**PROJECT REVIEW COMMITTEE - CITY OF WILDWOOD**  
**PRC Chairperson – Melanie Strickland**

**Agenda**  
**Regular Meeting**  
**May 12, 2026 10:00 AM**  
Commission Conference Room 124  
100 N Main Street

**RE: Northern Pines Subdivision (Project # A25-3061)  
Response to Review Comments  
(CFB No.EP2025.00286 )**

SHEET NUMBER 28

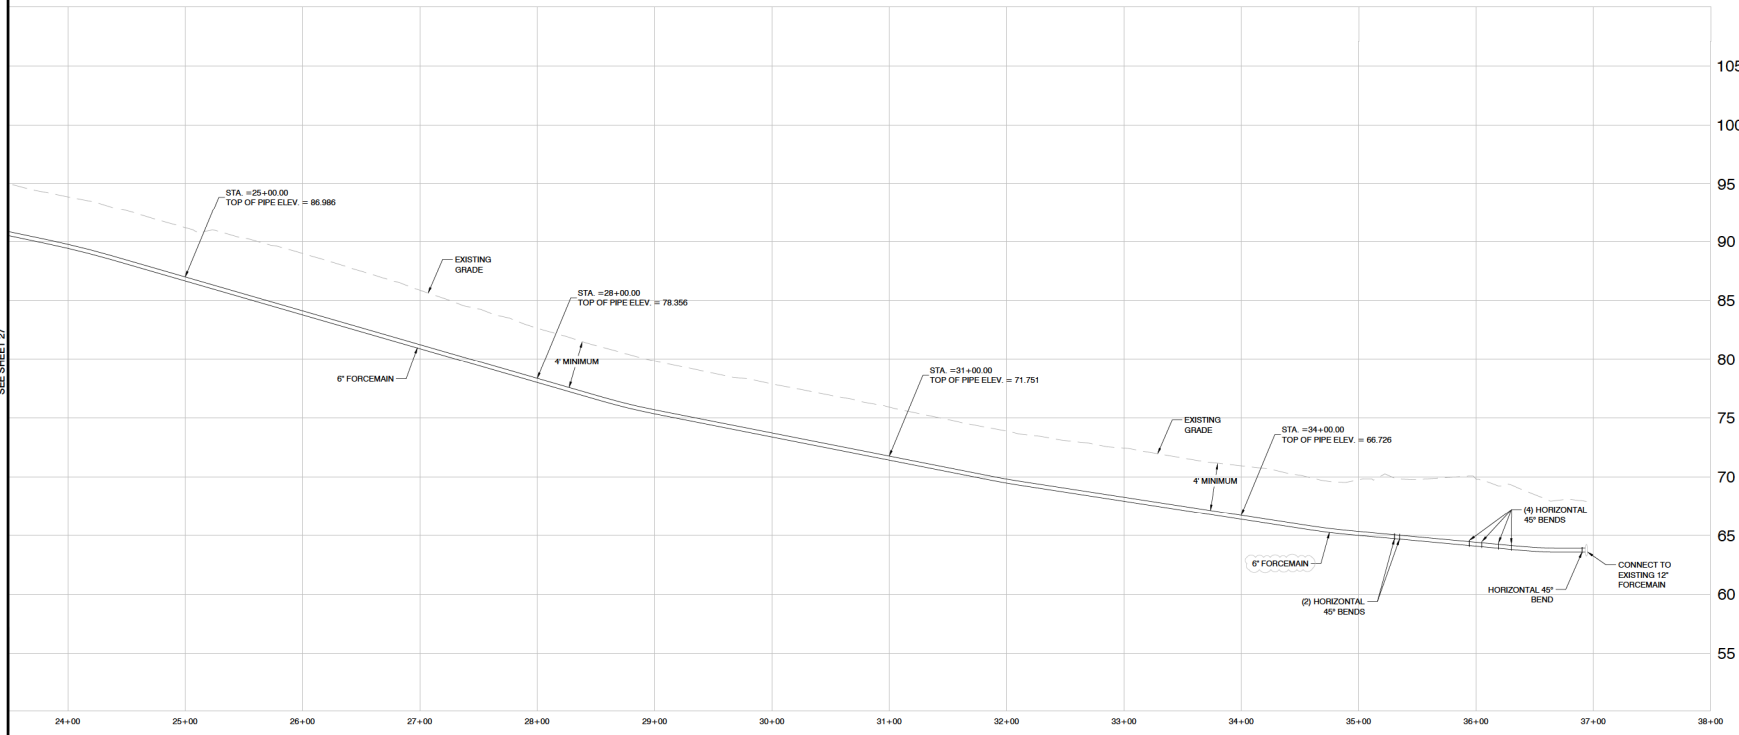
- 1. The connection to the existing force main is to be a wet tap with a stainless-steel sleeve and gate valve as per the Approved Materials List.**

Response: Sheet 28 has been updated to reflect this.
